Access Compliance Report

(Curb Ramps)

Intersection ID: 11845	Main Street: DUNWOODY_DR	Cross Street: STRANGFORD_AV	Location: W
ADA ID: 1175E79D1635	Ramp Type: BlendTrans1	Initial Pass/Fail: Fail	Overall Compliance: No
Severity Score: 10			
Codes/Mitigation Info/Possible Solution		Field Measurements/Component Compliance

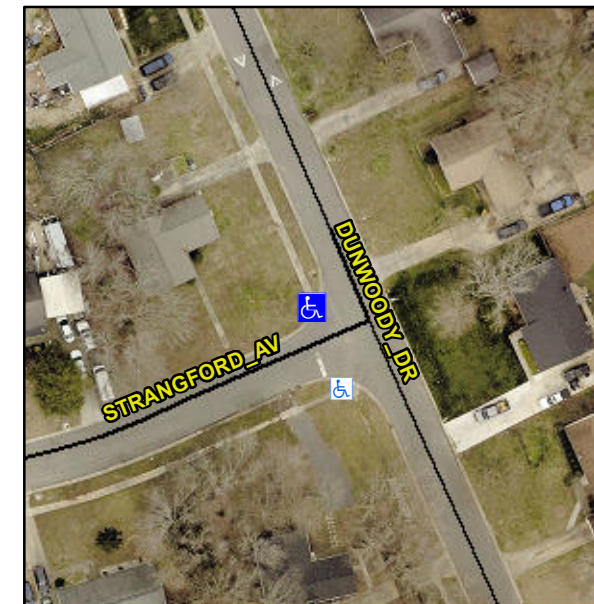
Not Found, R304.5.1, R304.5.3

Compliance	Description	Data	Compliance	Description	Data
N/A	Ramp Length (in)	36.5	Yes	BlendTrans Slope (%)	3.5
No	Ramp Width (in)	46.5	No	BlendTrans XSlope (%)	3.4
N/A	Flare Type LT	N/A	N/A	Flare Type RT	N/A
N/A	Flare Slope LT (%)	N/A	N/A	Flare Slope RT (%)	N/A
N/A	Flare Traversable LT?	N/A	N/A	Flare Traversable RT?	N/A
N/A	Landing Length (in)	N/A	N/A	DWS Provided?	N/A
N/A	Landing Width (in)	N/A	N/A	DWS Contrast?	N/A
N/A	Landing Slope (%)	N/A	N/A	DWS Length (in)	N/A
N/A	Landing X Slope (%)	N/A	N/A	DWS Full Width?	N/A
N/A	Landing Curb? (Y/N)	N/A	N/A	DWS Offset (in)	N/A
N/A	Shared Landing?	N/A			
N/A	Gutter Ponding?	N/A	N/A	Gutter Slope (%)	N/A
N/A	Gutter Lip Ht (in)	N/A	N/A	Gutter X Slope (%)	N/A
N/A	Painted X Walk1?	No	N/A	Painted X Walk2?	N/A
	X Walk 1 Direction	To SE		X Walk 2 Direction	N/A
	X Walk 1 Width (in)	N/A		X Walk 2 Width (in)	N/A
	X Walk 1 Slope (%)	2.6		X Walk 2 Slope (%)	N/A
	X Walk 1 X Slope (%)	1.7		X Walk 2 X Slope (%)	N/A

N/A	Ramp inside XWalk1?	N/A	N/A	Ramp inside XWalk2?	N/A
	Road Slope (%)	1.7		Clear Space?	N/A
	Road X Slope (%)	2.6	N/A	Clear Space to XWalk (in)	N/A
N/A	Any Obstructions?	N/A	N/A	Storm Grate/Utility Hazard?	N/A
	Obstruction Type			Storm Grate/Utility Type	
		N/A			N/A
			Yes	Surface Condition? (G/P)	Good
			No	Curb Slope (%)	11.3

Remove & Replace Curb Ramp With Two New Directional Ramps or Equivalent.
